VILLAGE OF MONROE

Workshop

July 13, 2026

236 High Street (Rest Haven)

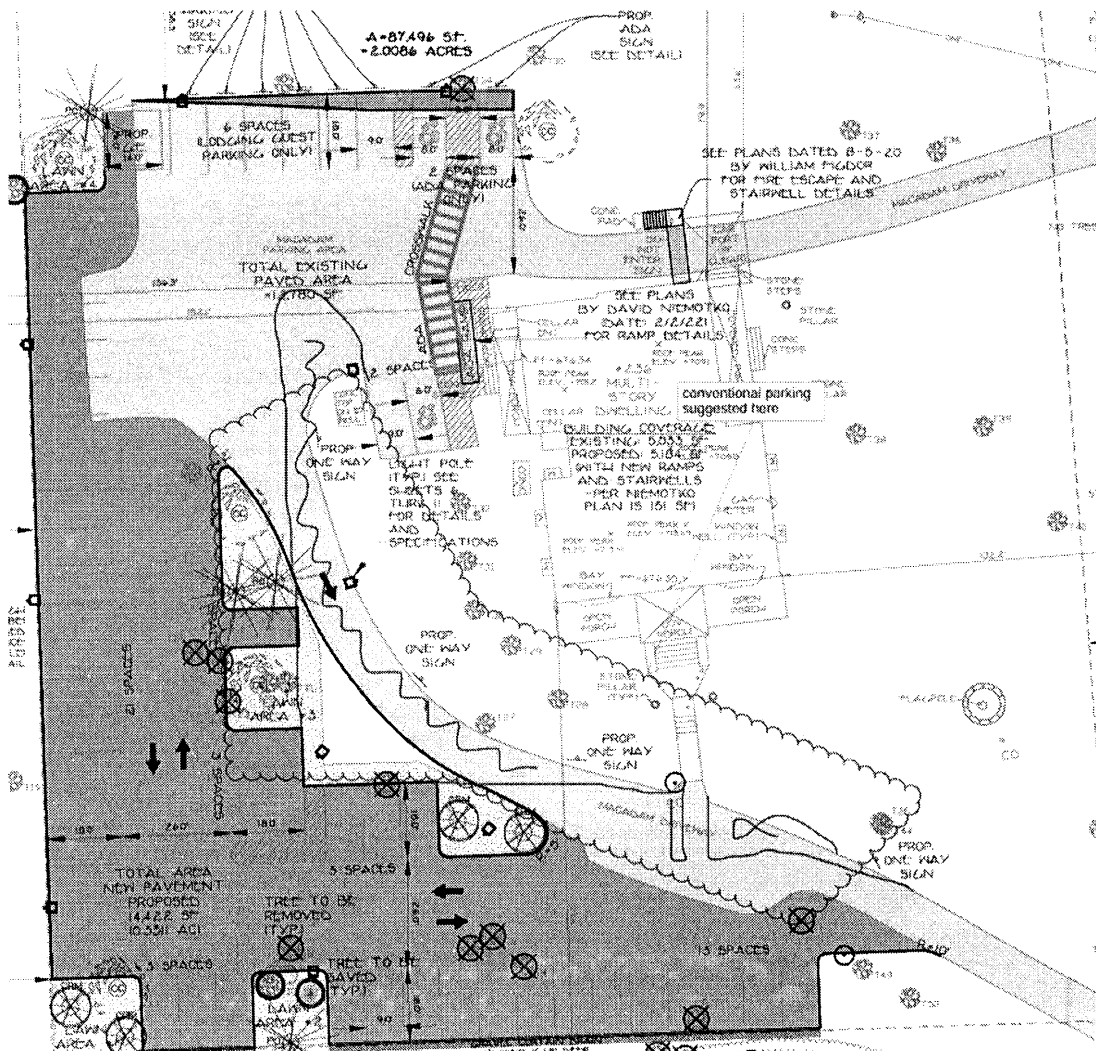
The Applicant should indicate which category the proposed restaurant will fall into, then provide a calculation (based on the number of gross square feet proposed for restaurant use, as well as the proposed number of seats) indicating how many parking spaces would be required.

It is noted that, for the “seats” calculation, the Applicant should include indoor and outdoor seats, if indoor and outdoor seats are intended to be occupied simultaneously. The Applicant should also provide parking calculation for the proposed lodging use (and the third-floor

office use – if it is not proposed to be accessory to the restaurant or lodging uses). Using these numbers, the Applicant should calculate the maximum parking demand required for the combination of uses on the property (expected to occur at 8 pm on a Friday or a Saturday).
